## MEMORANDUM

**MFG PROJECT: 180734**

**TO:** Dr. A. K. Ibrahim, U.S. Nuclear Regulatory Commission  
**FROM:** Roslyn Stern, Clint Strachan  
**DATE:** June 1, 2005  
**SUBJECT:** Sequoyah Fuels Corporation Site, Shear Wave Velocities  
**COPY:** Craig Harlin, Sequoyah Fuels Corporation

DISPOSAL CELL GEOLOGIC CROSS SECTIONS  
(VERTICAL EXAGGERATION 5:1)

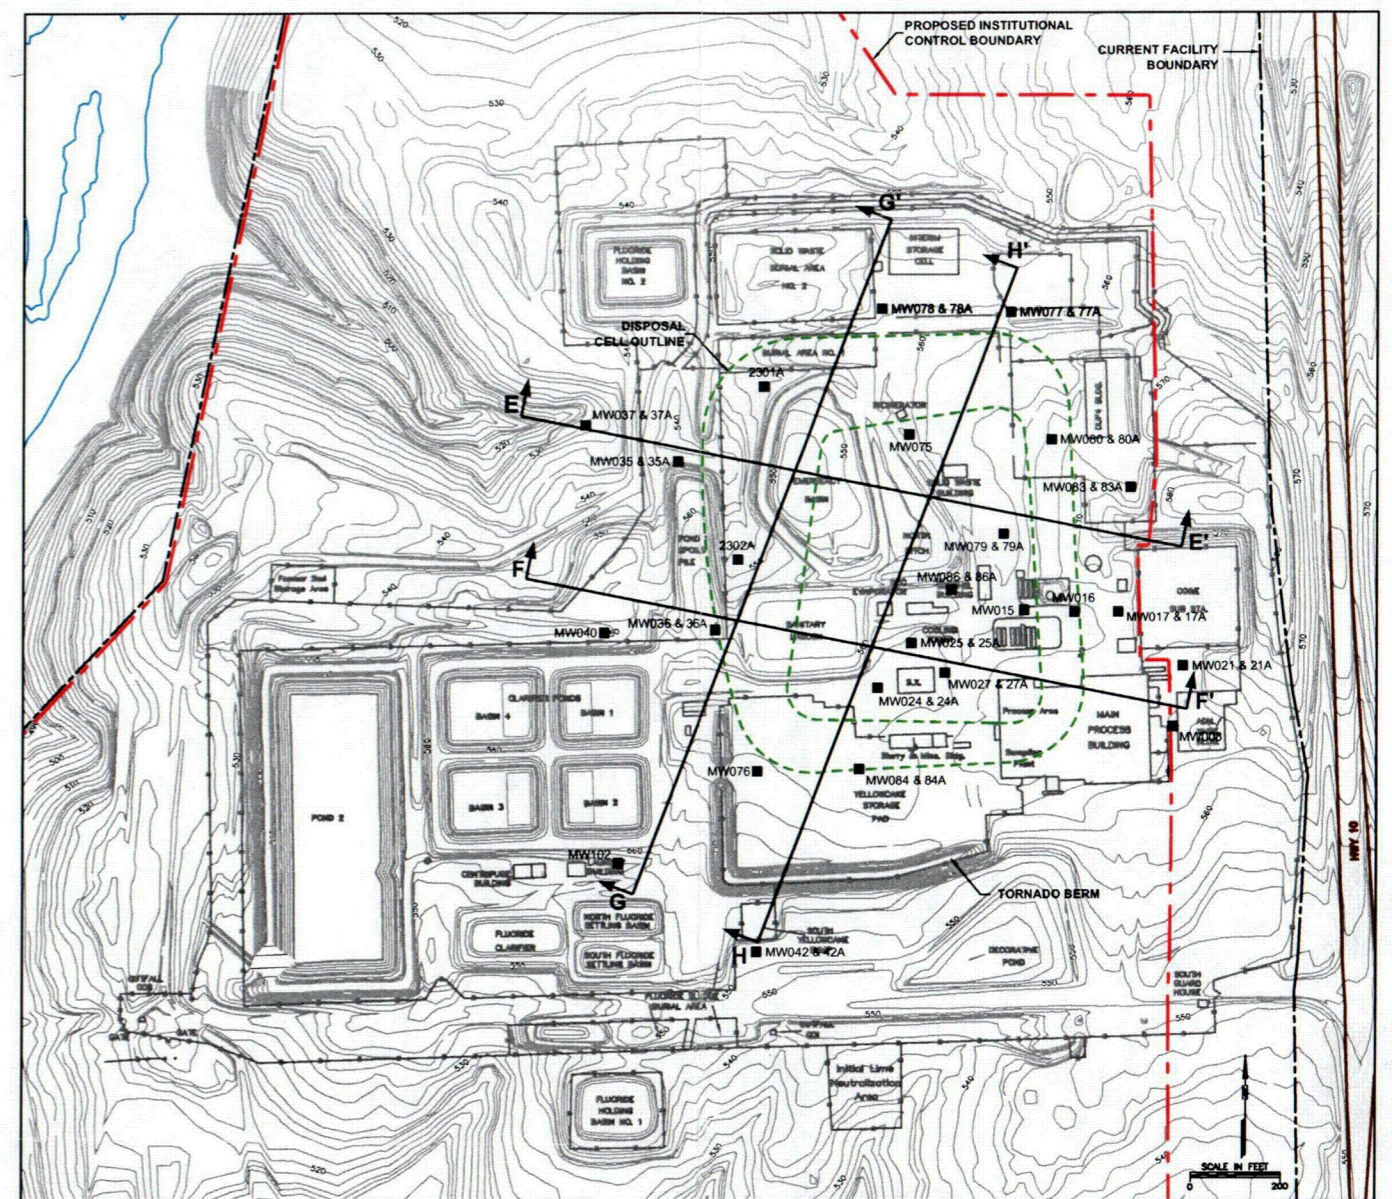
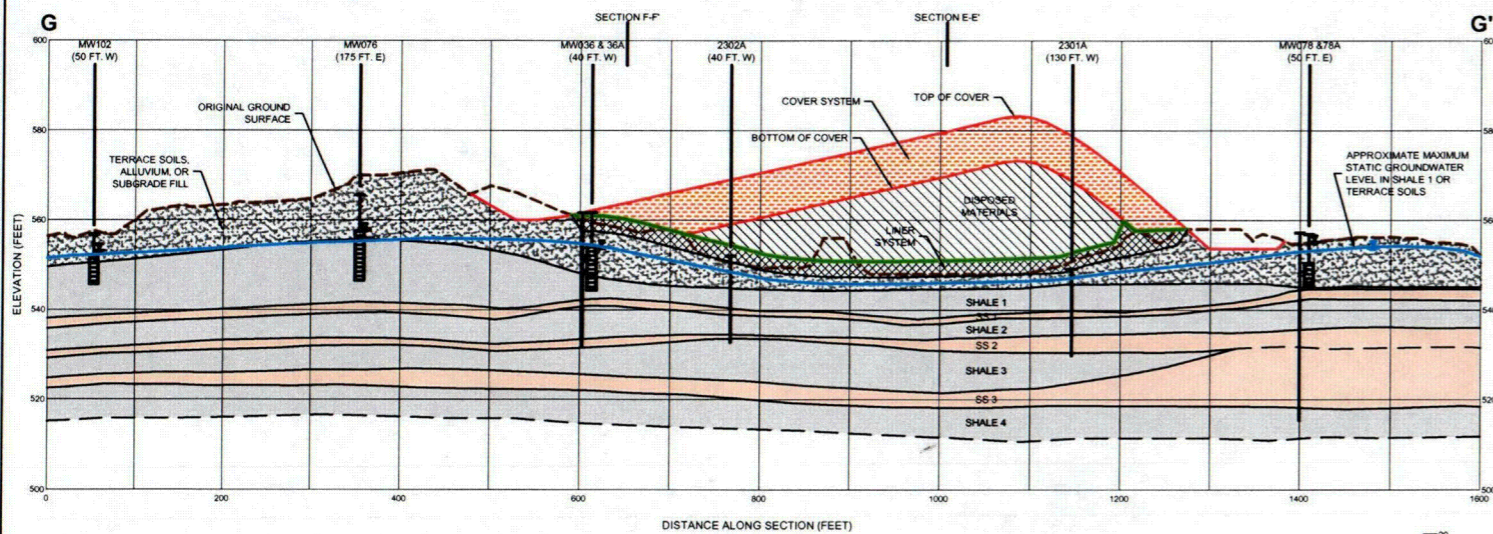
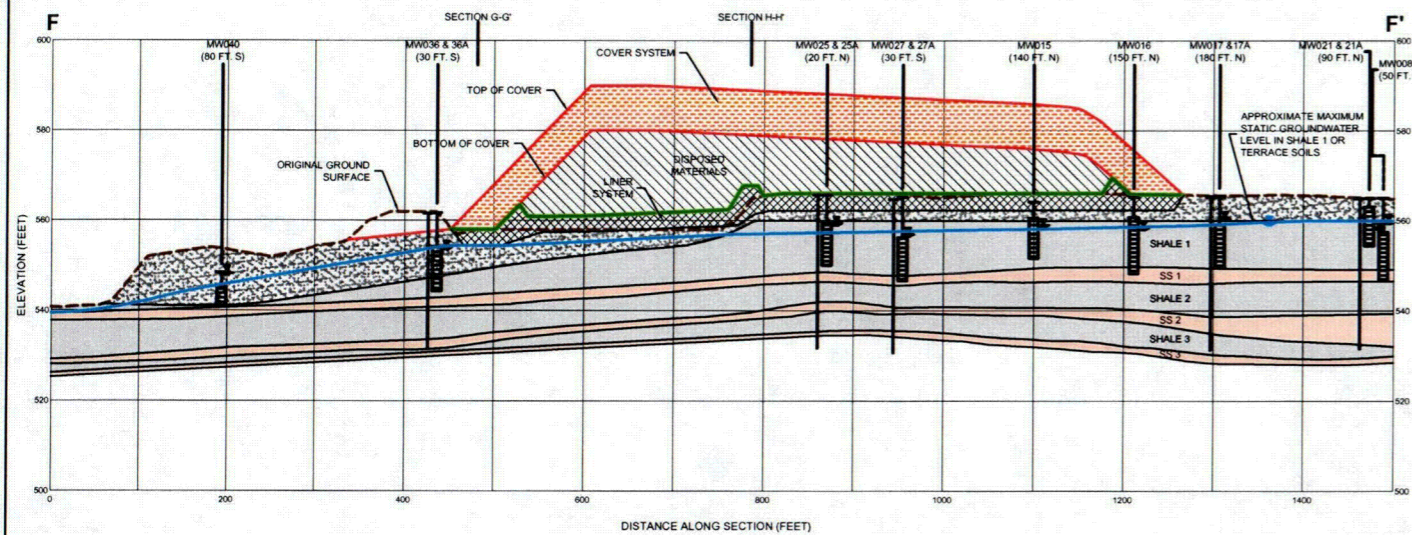
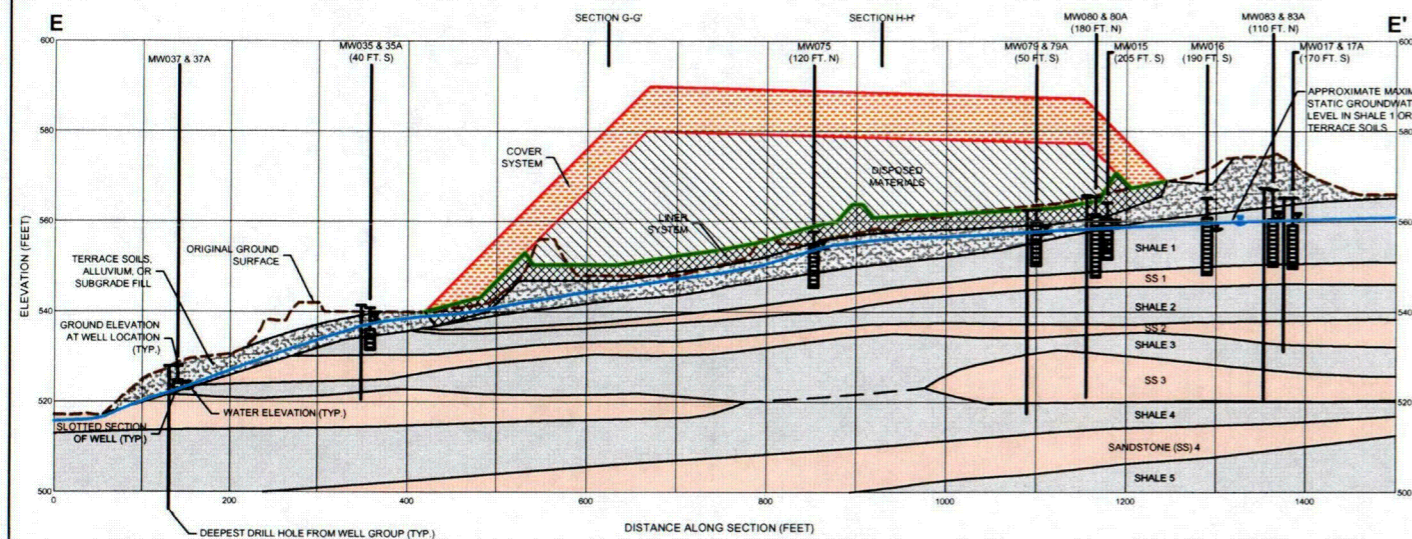
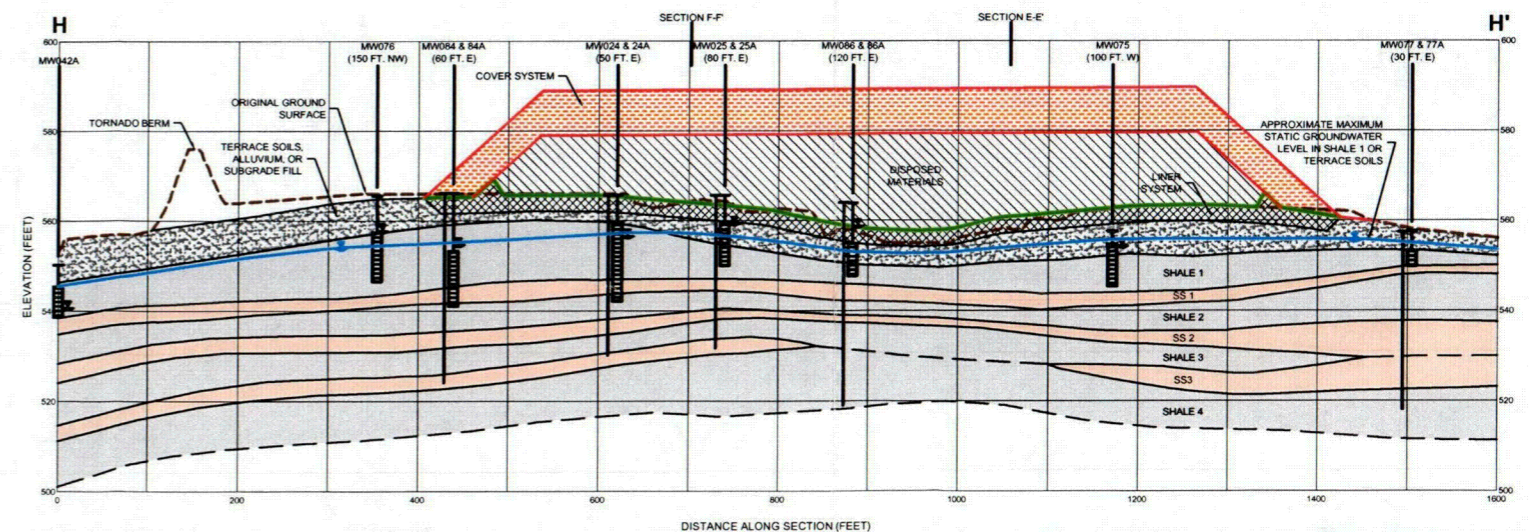
Request for Additional Information (RAI) Issue S8 asked for justification for not accounting for local soil amplification at the disposal site when calculating the design seismic ground motion. In the response to that RAI, MFG (MFG, 2004) explained that significant thicknesses of unconsolidated soils are not present in the disposal cell area. In addition, site soil cleanup work will remove most of the remaining terrace soils or other surface soils in the disposal cell footprint area. Therefore, no local soil amplification is anticipated for these foundation conditions. This is consistent with seismic analysis methods (such as Spudich and others, 1999) where soils less than 5 meters thick are not evaluated for amplification.

As shown in Drawing 14, terrace deposits estimated to be a maximum of 12 feet thick are overlying the Atoka Formation in the disposal cell footprint area. Boring logs in the area (Hemphill Corporation, 1980 and Roberts/Schornick and Associates, Inc, 1990) describe the terrace deposits as varying from gravelly silty clay, silty clay, to clay. Consistency is soft to firm with an average dry unit weight of approximately 105 pcf. The majority of these soils will be excavated during subsoil clean up, then placed and compacted within the disposal cell.

The disposal cell footprint is likely to have an irregular surface from areas that have been excavated during subsoil cleanup. Subgrade fill will be used in excavated areas of the disposal cell footprint to meet desired grades and elevations for the disposal cell foundation (shown on the Drawing 14). Depths of

subgrade fill will be sufficient to maintain the base of the compacted clay liner of the disposal cell a minimum of three feet above the maximum observed groundwater level. Subgrade fill will consist of off-site granular materials, or soils and weathered sedimentary rock from approved on-site excavation areas. Subgrade fill will be compacted in 12-inch lifts. The depths of compacted granular fill versus remaining in-place terrace materials is unknown at this time. However, the total depth of unconsolidated soil material underlying the disposal cell will vary from negligible amounts to a maximum of ten feet, with an average depth of five feet.

Geophysical testing has not been performed at the site. However, the underlying Atoka Formation units are of the same geologic age and geophysical province as the Pennsylvanian units evaluated in the Black Fox Geotechnical Investigation. Measured shear wave velocities at Black Fox were greater than 2,000 feet per second in the upper weathered zone (20 to 30 feet thick), and were greater than 4,000 feet per second below the weathered zone. The National Earthquake Hazard Reduction Program (FEMA, 1995) and the International Building Code (IBCO, 2000) site class definitions for these materials are site class B in the upper 20 to 30 feet, and the site class A below this depth. The corresponding ground-motion amplification through these materials is expected to be negligible.

Shear wave velocities of the terrace clays are estimated using empirical correlations as developed by various authors (Hardin and Richart 1963, Hardin and Drnevich 1972, Kanai 1966, Ohsaki and Iwasaki 1973, Ohta and Goto 1978, Imai and Tonouchi 1982, Sykora and Stokoe 1983, Fumal 1978, and Fumal and Tinsley 1985) as compiled by Sykora (1987). The empirical correlations estimate shear wave velocities based on void ratio, effective confining pressure, and Standard Penetration Test (SPT) blow counts. For these correlations, the void ratio of the clay is estimated to be approximately 0.63 based on a dry unit weight of 105 pcf and an assumed specific gravity of 2.75. Effective confining pressure is approximately 3,300 psf based on an average height and unit weight of disposal cell material of 30 feet and 110 pcf, respectively. SPT blow counts are assumed to be approximately 15, corresponding to a stiff clay. It is assumed that any clays encountered that are softer than this would be removed before construction of the disposal cell. Calculated shear wave velocities using various relationships ranged from approximately 700 to 1200 fps, with a median value of approximately 770 fps.

Shear wave velocities of the compacted granular materials are also estimated using empirical correlations related to void ratio, effective confining pressure, and Standard Penetration Test (SPT) blow counts (Sykora, 1987). For these correlations, the void ratio of the compacted granular fill is estimated to be approximately 0.50 based on a dry unit weight of 110 pcf and an assumed specific gravity of 2.65. Effective confining pressure is approximately 3,300 psf based on an average height and unit weight of disposal cell material of 30 feet and 110 pcf, respectively. SPT blow counts are assumed to be approximately 25, corresponding to medium dense sand. Calculated shear wave velocities using various relationships ranged from approximately 650 to 1500 fps, with a median value of approximately 920 fps.
